Access Compliance Report

Intersection ID: 28945	Main Street: CRESCENT_VIEW_DR	Cross Street: MALLARD_CREEK_RD	Location: SW
ADA ID: CF1C51D4ABF8	Ramp Type: Perp	Initial Pass/Fail: Fail	Overall Compliance: No
Severity Score: 47.5			
Codes/Mitigation Info/Possible Solution		Field Measurements/Component Compliance

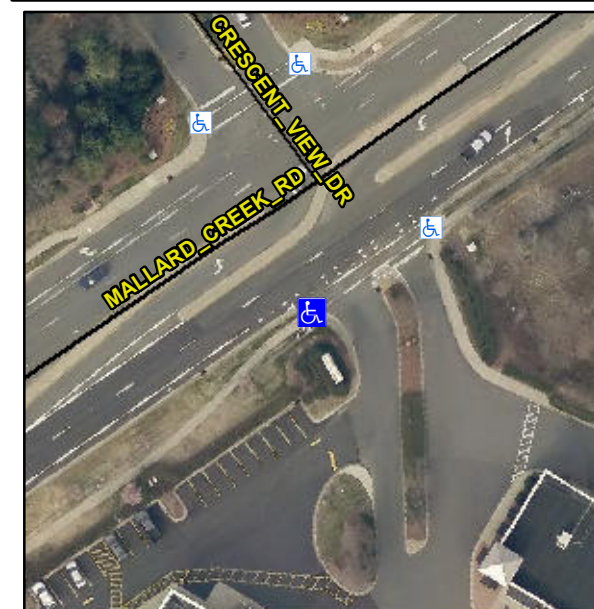
R304.5.1, R304.2.2

Compliance	Description	Data	Compliance	Description	Data
N/A	Ramp Length (in)	78.5	No	Ramp Slope (%)	10.3
No	Ramp Width (in)	28.0	Yes	Ramp XSlope (%)	0.2
N/A	Flare Type LT	N/A	N/A	Flare Type RT	N/A
N/A	Flare Slope LT (%)	N/A	N/A	Flare Slope RT (%)	N/A
N/A	Flare Traversable LT?	N/A	N/A	Flare Traversable RT?	N/A
N/A	Landing Length (in)	N/A	N/A	DWS Provided?	N/A
N/A	Landing Width (in)	N/A	N/A	DWS Contrast?	N/A
N/A	Landing Slope (%)	N/A	N/A	DWS Length (in)	N/A
N/A	Landing X Slope (%)	N/A	N/A	DWS Full Width?	N/A
N/A	Landing Curb? (Y/N)	N/A	N/A	DWS Offset (in)	N/A
N/A	Shared Landing?	N/A			
N/A	Gutter Ponding?	N/A	N/A	Gutter Slope (%)	N/A
N/A	Gutter Lip Ht (in)	N/A	N/A	Gutter X Slope (%)	N/A
N/A	Painted X Walk1?	Yes	N/A	Painted X Walk2?	N/A
	X Walk 1 Direction	To NE		X Walk 2 Direction	N/A
N/A	X Walk 1 Width (in)	81.0	N/A	X Walk 2 Width (in)	N/A
	X Walk 1 Slope (%)	1.0		X Walk 2 Slope (%)	N/A
	X Walk 1 X Slope (%)	3.6		X Walk 2 X Slope (%)	N/A

Remove & Replace Entire Ramp.
